January 17, 2023
ADDENDUM NUMBER THREE
Project No. ENG2201760232
For Department of Natural Resources

PROJECT DESCRIPTION:
 PATOKA SOUTH BOAT RAMP
 IMPROVEMENTS

SHEET TITLE:
 SITE PLAN

SHEET NUMBER:
C-2

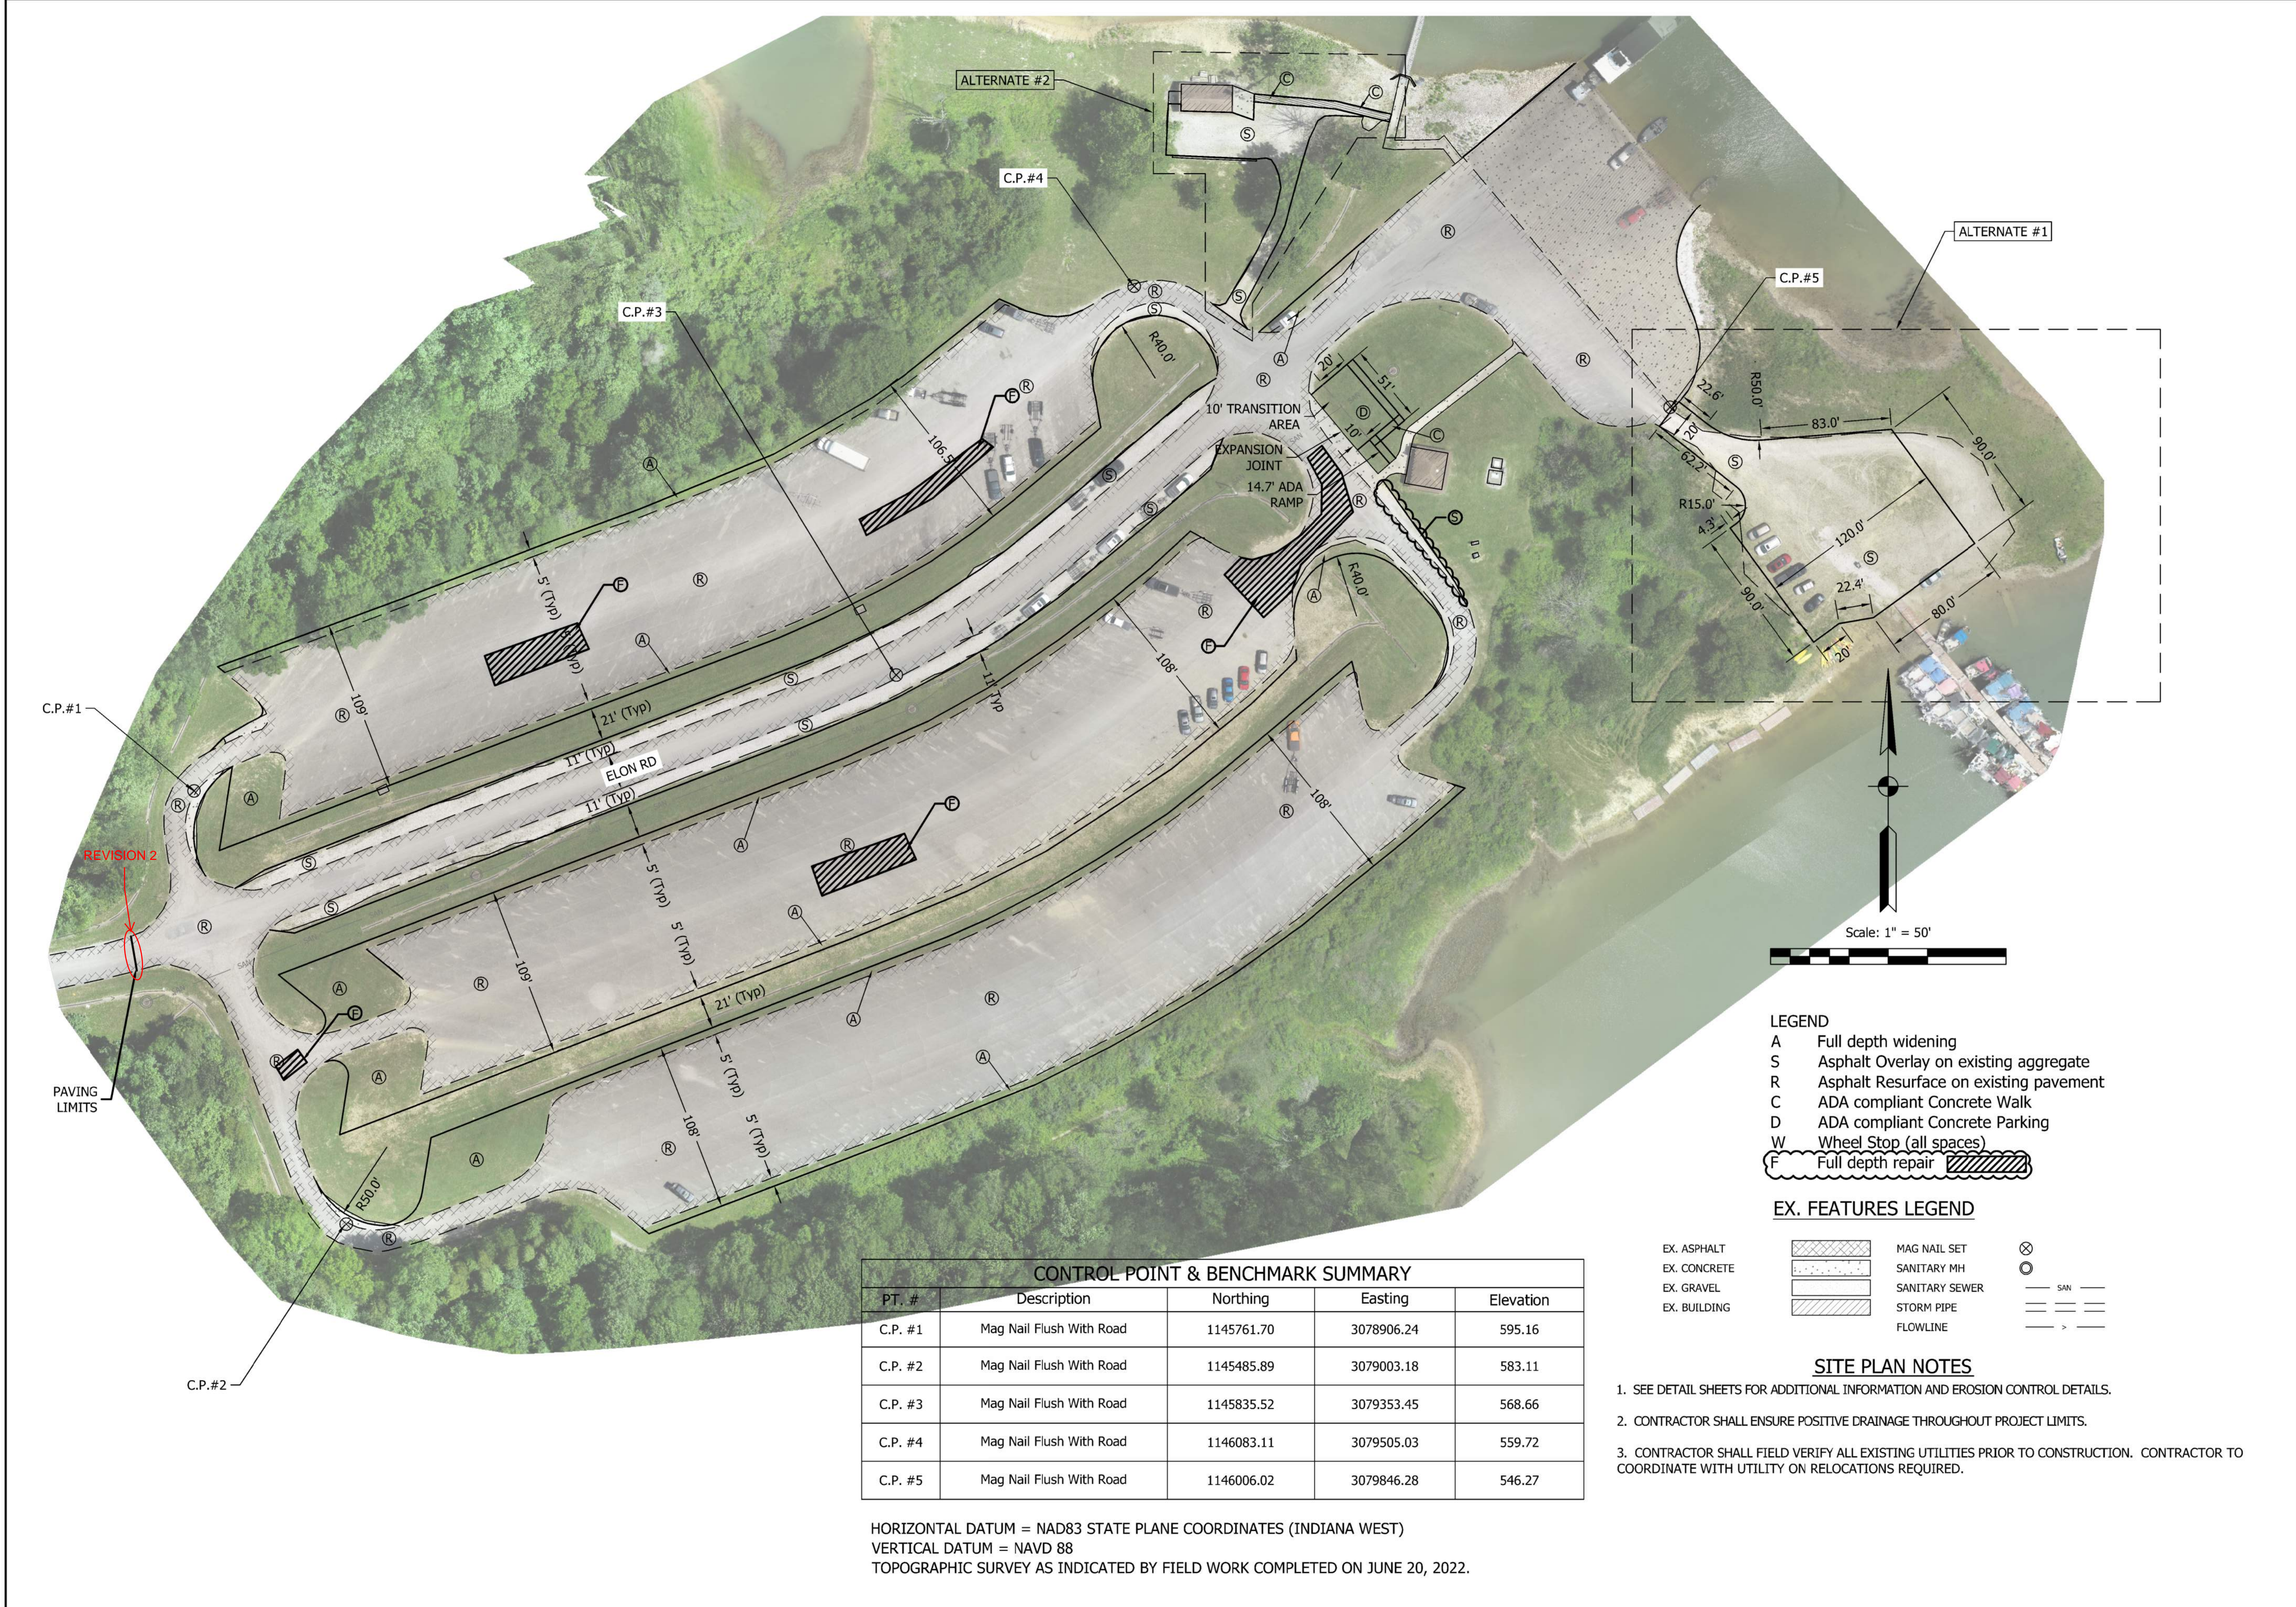
Drawing Revisions – Sheet C-2 Revision 2 (attached)

ITEM NO. 3 – Contractor Question: Where should the asphalt surface start on the entrance road? Is there a particular spot or where the lines start on the prints good enough? A: The asphalt surface shall start at the beginning of the radius as shown on Sheet C-2 Revision 2.

ITEM NO. 9 – Contractor Question: Just wanted to clarify...sheet C-2 designates “R” as asphalt resurface over existing pavement. The detail sheet calls out milling, Does the area listed as “R” get milled to a certain depth and 1.5” resurface or just get 1.5” resurface?? A: All existing asphalt shown to be resurfaced shall be milled 1.5” and 1.5” of resurface applied as shown in the provided detail for resurfacing.
